**METROPOLITAN GOVERNMENT OF NASHVILLE AND DAVIDSON COUNTY**

**STAFF RECOMMENDATION**  
**1514 Clayton Avenue**  
**September 16, 2020**

**Application:** Show Cause; New Construction—Infill (Materials)  
**District:** Belmont-Hillsboro Neighborhood Conservation Zoning Overlay  
**Council District:** 18  
**Base Zoning:** R8  
**Map and Parcel Number:** 11708015600  
**Applicant:** Moyo Suarez, Palmetto Construction  
**Project Lead:** Melissa Sajid, [melissa.sajid@nashville.gov](mailto:melissa.sajid@nashville.gov)

Figure 1. 1514 Clayton Avenue, August 2020.

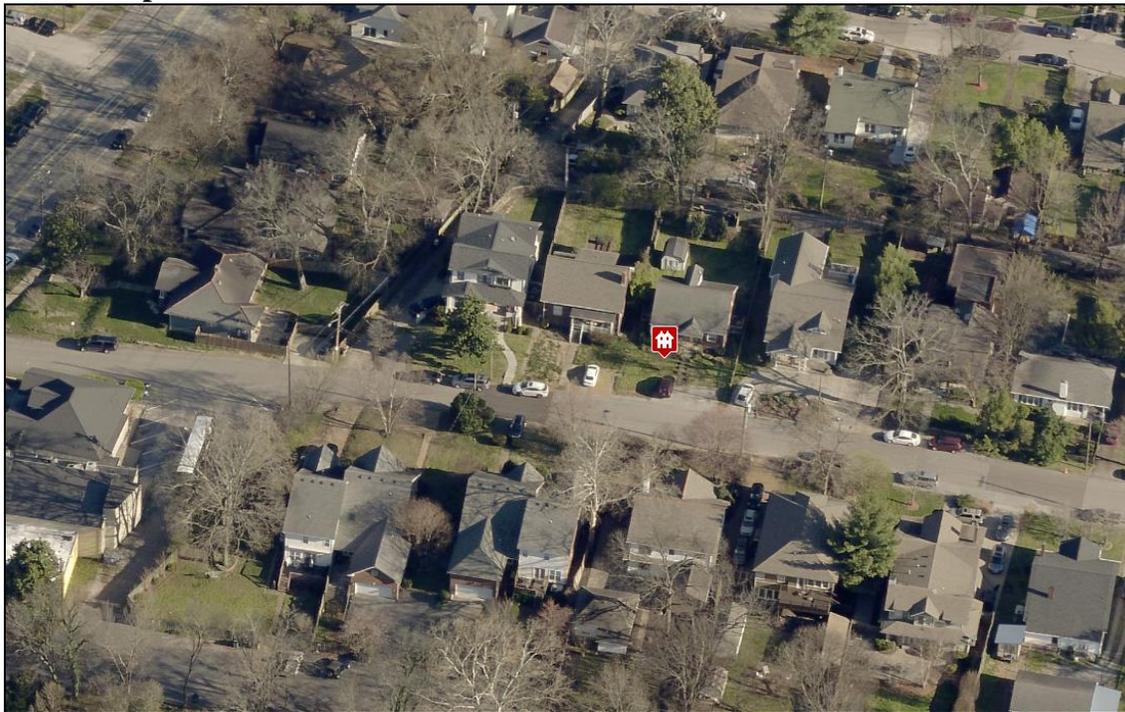
**Background:** The Commission approved infill at 1514 Clayton Avenue in November 2019 (HCP 2019068353; Attachment B). The new house is under construction but appears to be near completion (Figure 1).

**Materials:** The brick is located on the foundation, front porch columns, and gabled entry way (Figure 1). The brick foundation only extends the first twenty-five feet (25’) on the left-side façade and is not used as a foundation material on the right-side façade (Figure 2).

Staff finds that the brick as installed does not meet the design guidelines with respect to its color and texture. The color of the brick, which is lightened likely by a mortar rub, is lighter than historic examples on this block of Clayton Avenue. Figure 2 shows the infill next to the contributing brick house next door at 1516 Clayton Avenue. The bricks themselves exhibit a rougher distressed texture that is not typical of historic brick (Figure 3). There are several examples of painted brick on this block, but staff would not recommend that as a solution since the texture of the brick also does not meet the design guidelines.

Staff finds that the color and texture of the brick do not meet Section II.B.1.d of the Belmont-Hillsboro design guidelines and recommends that the brick be replaced with brick that meets the design guidelines.

**Recommendation:** Staff recommends disapproval of the brick as installed, finding it does not meet Section II.B.d of the *Belmont-Hillsboro Neighborhood Conservation District: Handbook and Design Guidelines*.
